Product Change Notice (PCN)

PCN Number: **PCN-0450024R-01**

Product(s) Affected: **PJ-075DH-SMT-TR**

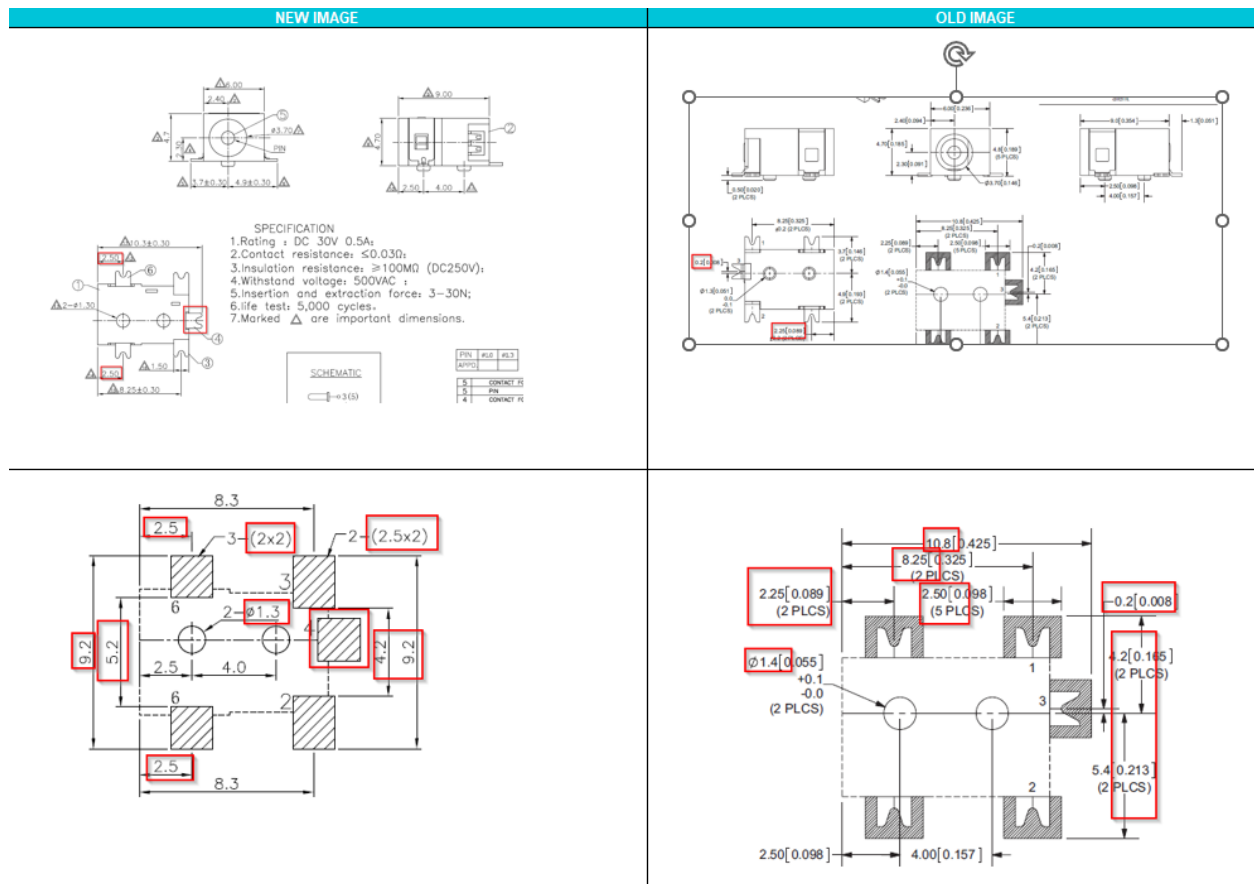
Description of Change: **Minor Housing and footprint differences. Material Change on the housing and terminals. See image Below**

Housing and Terminal Material Changes:

Center Pin: Copper to Brass

Terminal 2: Copper Alloy to Brass

Plastic: PA6T or Equivalent to PA9T
